Highways Response Letter - Land South of Bedwell Road, Elsenham

EAS has been commissioned to respond to the highways comments raised by Essex County Council (ECC) regarding planning application ref: S62A/2024/0049 at the above address.

Appendix A – SK13 Visibility Splays

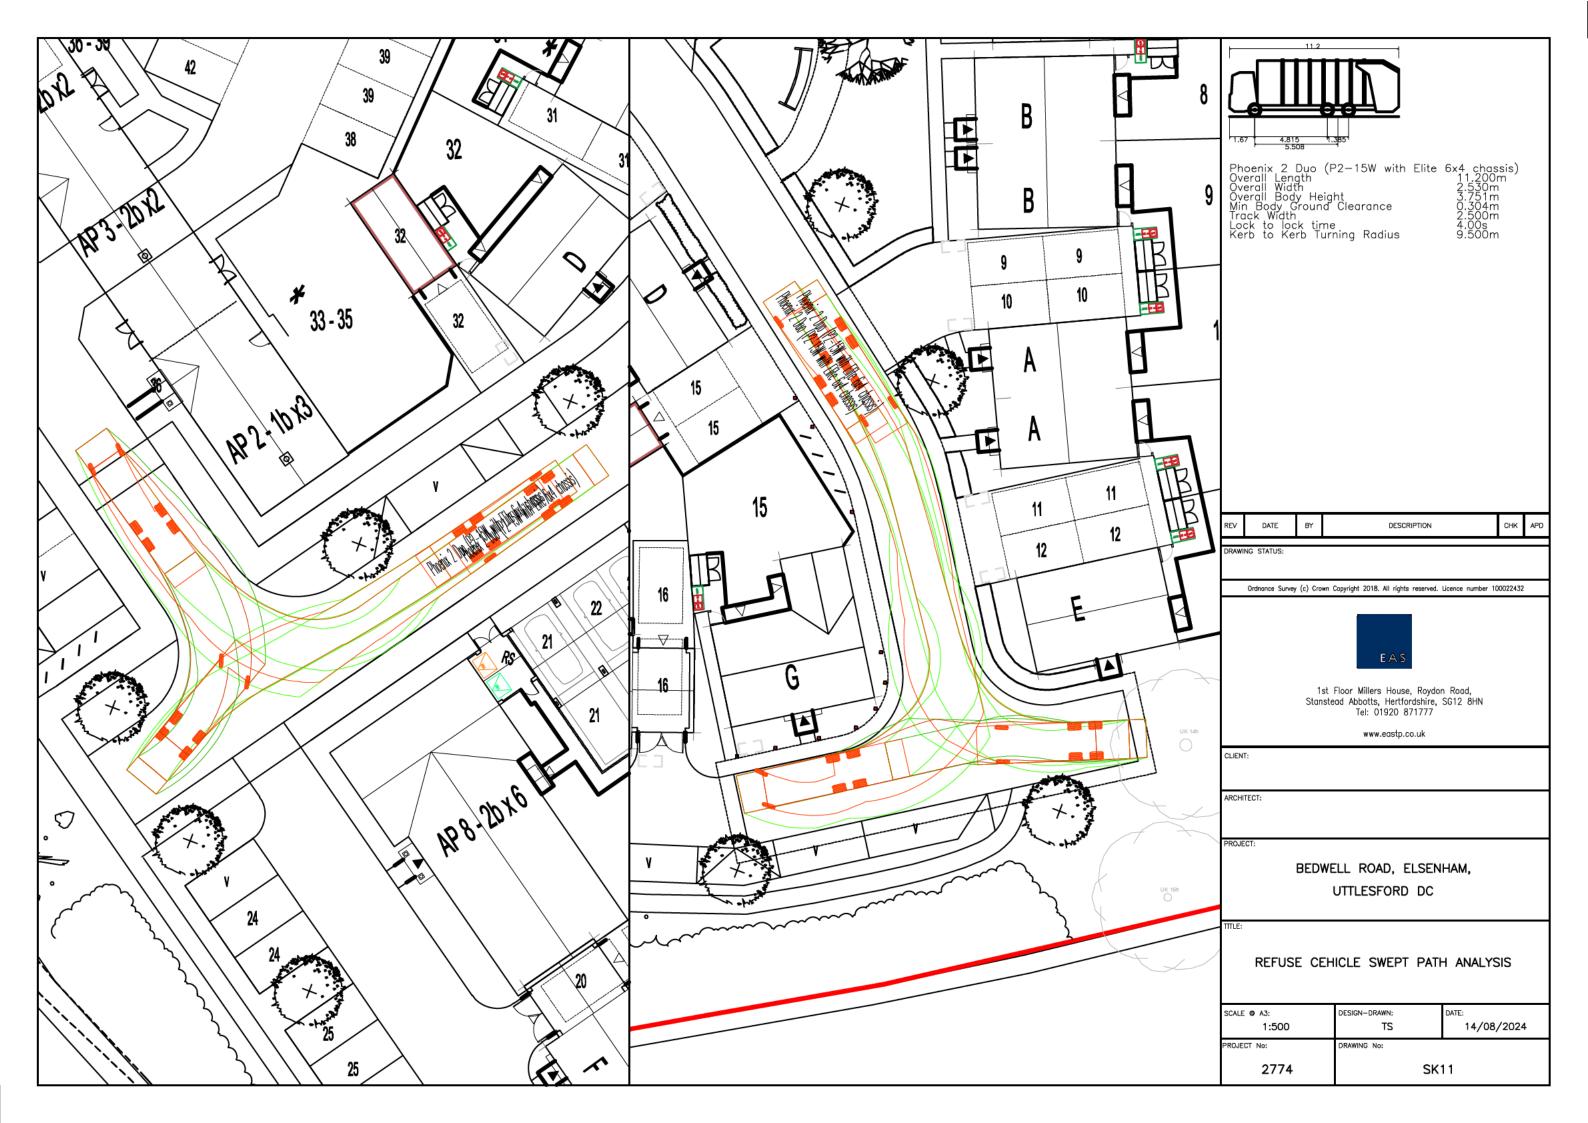
"- The coloured plan indicates trees planted within visibility splays for the accesses for plots 30, 31, 32, and access to private drive 33-50."

Please see the attached visibility splay drawings (SK13), contained at **Appendix A**, demonstrating the extents to which the trees fall within the required splays. It should be noted that as per Manual for streets paragraph 7.8.6, that "The impact of other obstacles, such as street trees and street lighting columns, should be assessed in terms of their impact on the overall envelope of visibility. In general, occasional obstacles to visibility that are not large enough to fully obscure a whole vehicle or a pedestrian, including a child or wheelchair user, will not have a significant impact on road safety." Therefore, it is deemed that the demonstrated trees would not have any adverse effect on the achievable visibility and highway safety. In any case, the tree locations can be moved outside of the visibility envelopes as part of a planning condition if deemed necessary.

Appendix B – SK11 Refuse Vehicle Swept Path Analysis

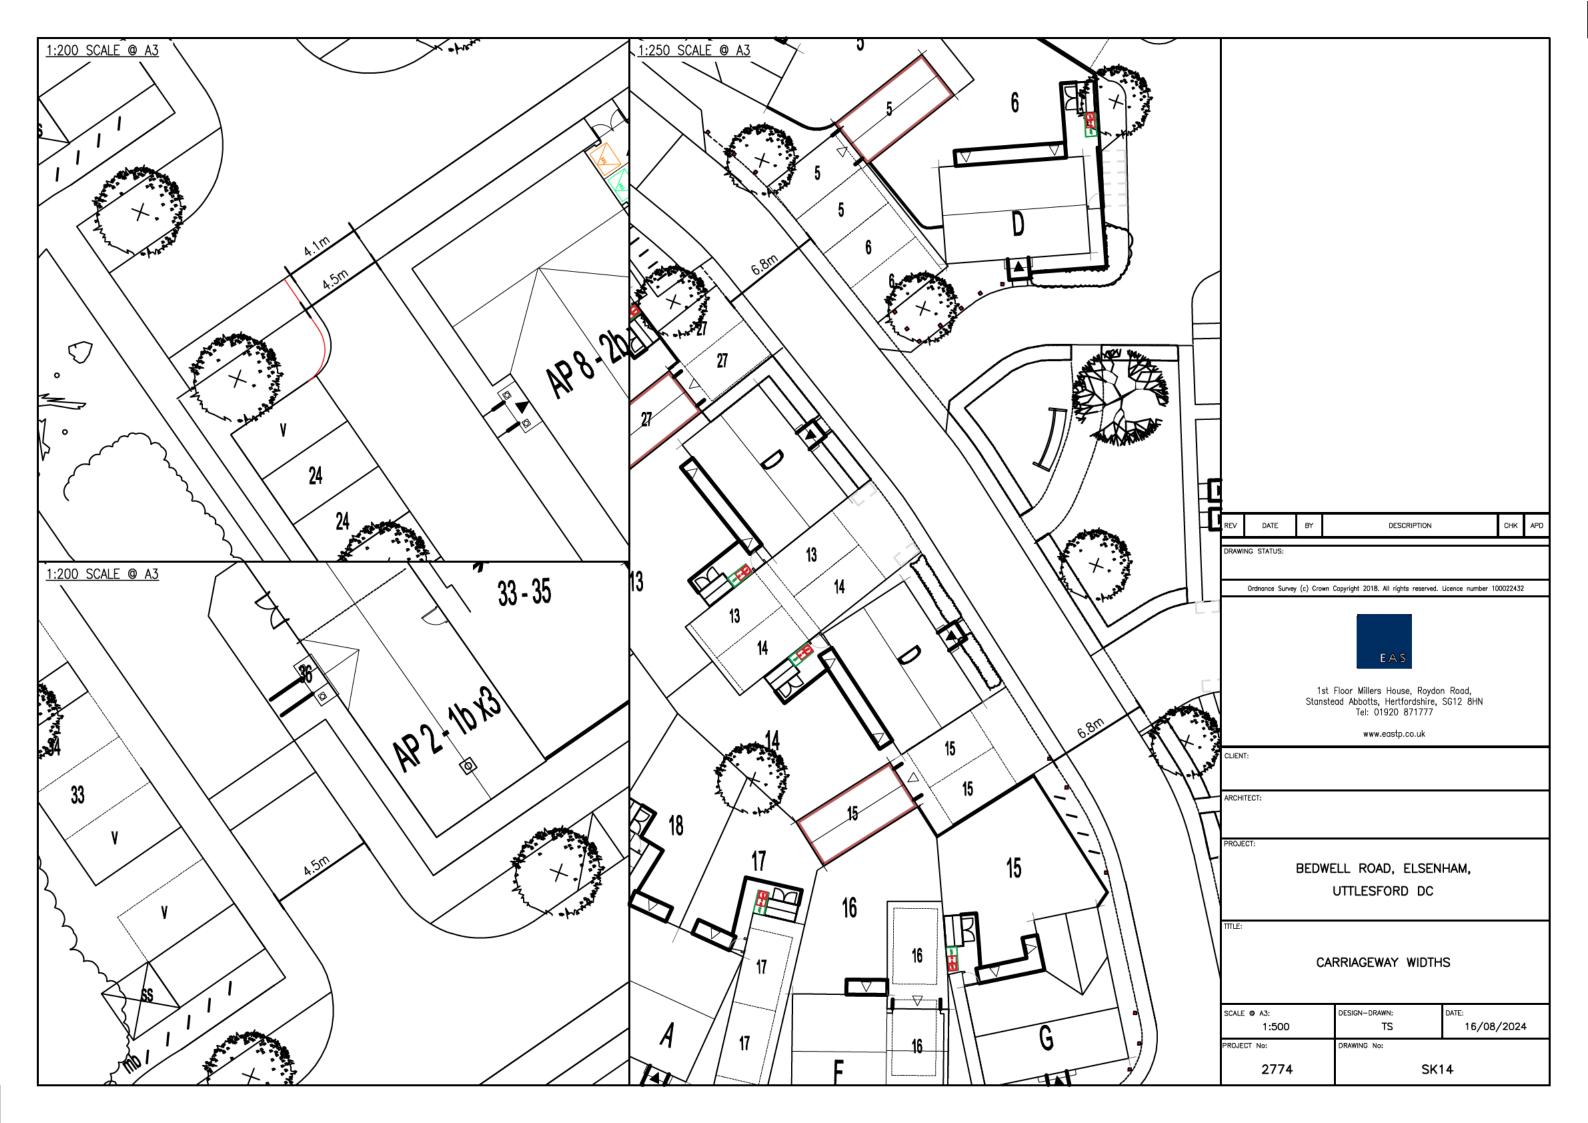
"The turning heads provided should be a size three and be accompanied by swept path analysis drawings demonstrating adequate manoeuvrability for refuse vehicles used by Uttlesford District Council"

Please see swept path analysis drawing SK11, contained at **Appendix B**, demonstrating a refuse vehicle successfully turning within the site. These movements allow for the refuse vehicle to service the site as per the refuse collection plan highlighted at p30 of the Design and Access Statement attached.
